**SITE PLAN REVIEW SHEET
ENVIRONMENTAL VARIANCE REQUEST ONLY**

CASE: SP-2023-0032C

PROJECT NAME: Estancia Phase 11 Condos

DESCRIPTION OF VARIANCES:

Cut/Fill & Slopes Exhibit

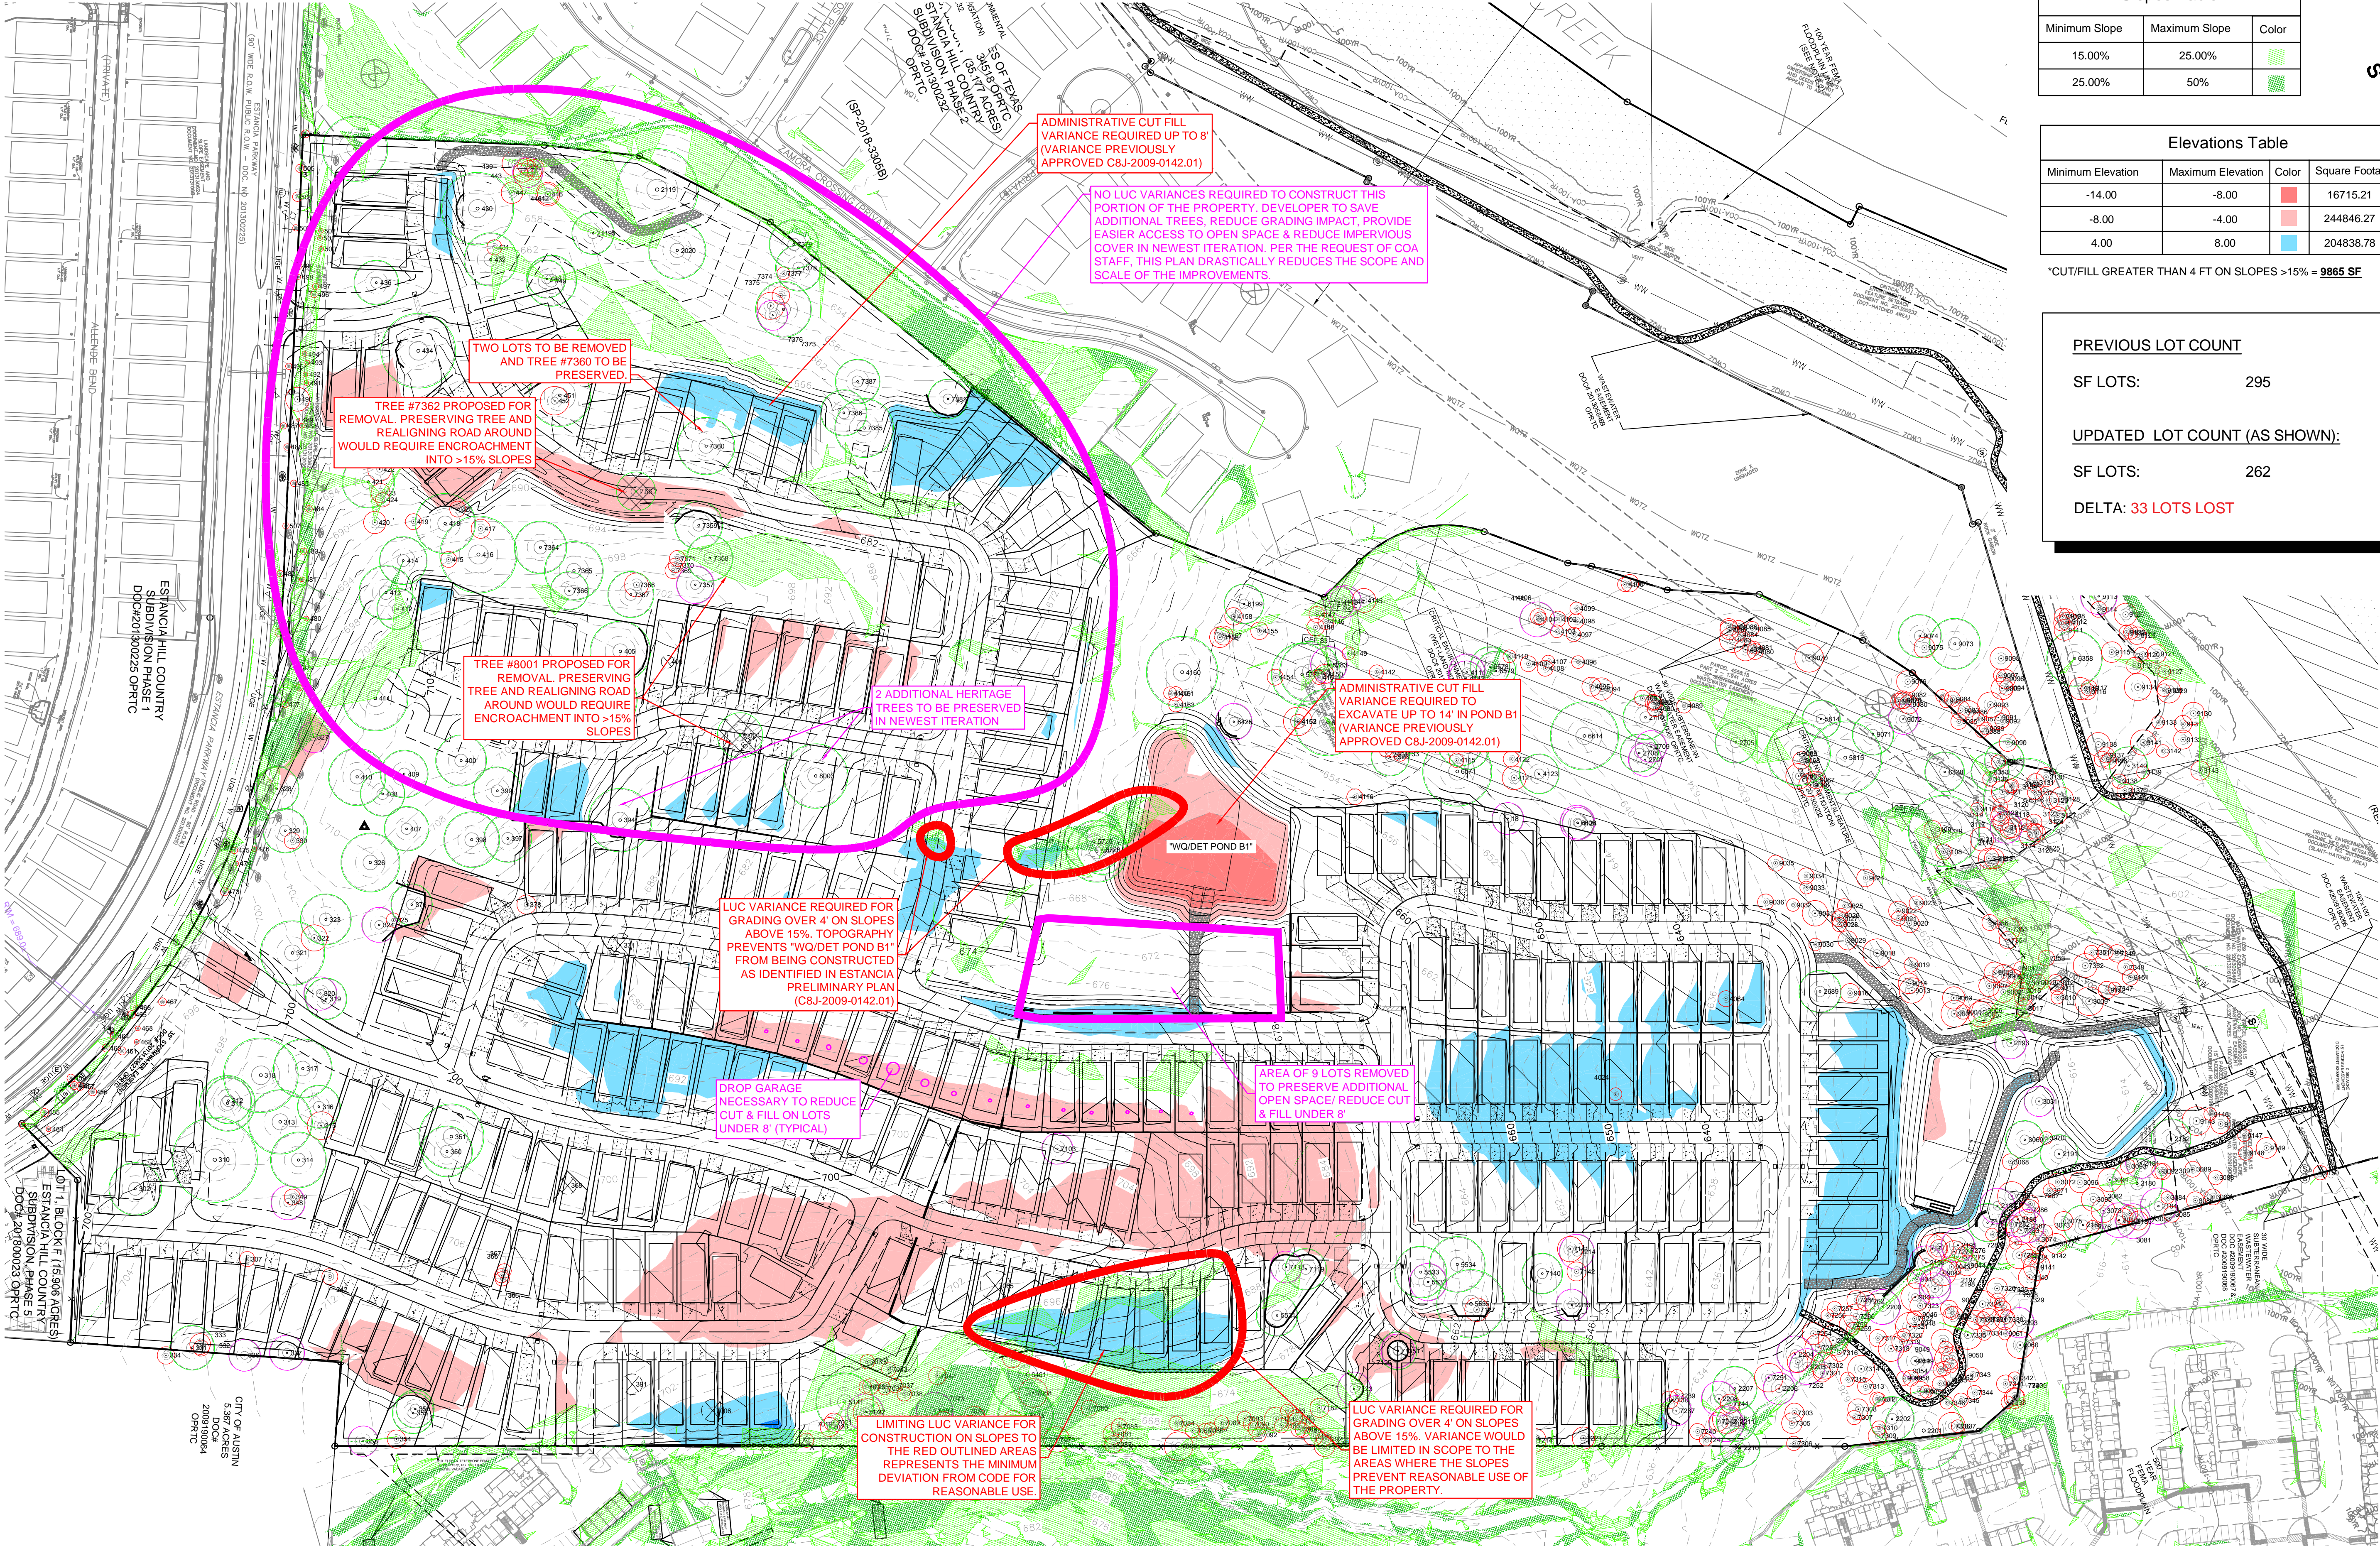
The development proposes variances from LDC 25-8-341 for cut greater than 4 feet on slopes greater than 15% and LDC 25-8-342 for fill greater than 4 feet on slopes greater than 15%

Yes / No The method to develop the property is a typical method used on properties throughout the City and on the properties adjacent to this project. The current design proposal may provide greater overall environmental protection than is achievable without this variance by installing 2 biofiltration ponds, 50% more trees than required by landscape code, and a retaining wall, 609S native seeding/planting, and erosion matting in the area of steep slopes behind lots.

Yes / No The regulatory history of this property should be noted. The Estancia Hill Country PUD as well as Preliminary Plan C8J-2009-0142.01 both adjust code to allow for increased grading and increased development on steeper slopes. The preliminary plan allows for grading up to 14 feet for pond construction and grading up to 8 feet throughout. The PUD stipulates that parking, driveways, and ROWs may be constructed on slopes up to 25%. However, the code adjustments do not specifically address grading which occurs on steep slopes. These grading scenarios are as follows: 1) To construct the project with the pond locations agreed upon in the preliminary plan, some grading over 4 feet on slopes over 15% is required. 2) A portion of the scope of this variance request is to construct a driveway on slopes greater than 15% utilizing a small amount of grading over 4 feet. Efforts have been taken to realign the roadways in order to avoid this situation to the extent practicable. 3) The rest of the grading over 4 feet which is also on slopes greater than 15% is to allow for the construction of ~6 condo units.

The only grading greater than 8 feet is to construct the pond in order to contain the necessary stormwater volume.

- 1) Ponds onsite will be biofiltration ponds,
- 2) Plant 50% more trees than required by landscape code,
- 3) Retaining wall, 609S seeding/planting, and erosion control matting in areas of steep slopes behind lots

1. Ponds onsite will be biofiltration ponds
2. Plant 50% more trees than required by landscape code
3. Retaining wall, 609S seeding/planting, and erosion matting in areas of grading on steep slopes behind lots
